Request for Further Information Pursuant to Section 92(1) of the Resource Management Act 1991

Service Request Type:	Resource Consent
Site Address:	292 Tawa Road, Tawa
Legal Description:	Lot 1 DP 15312
Consent Type:	Land Use
Consent Description:	Establishment and use of a four story building containing 24 household units

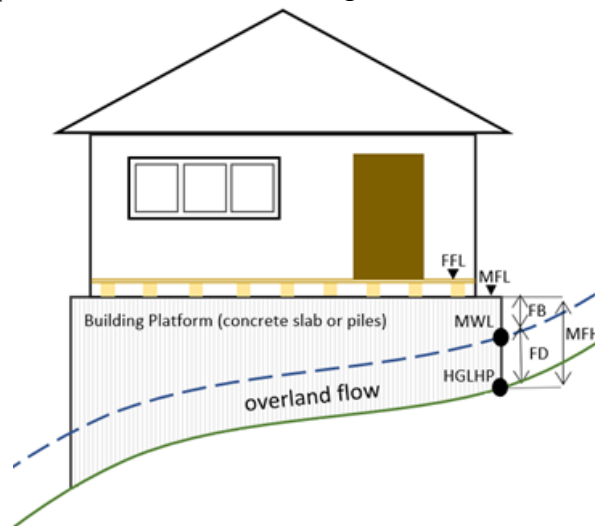
It is recommended that the main access to the apartment building needs to be improved. For example:

- Provide a sheltered threshold
- Include a lobby area that provides adequate space to allow for furniture moving, and people to wait. Include areas for mailboxes and a secure parcel drop
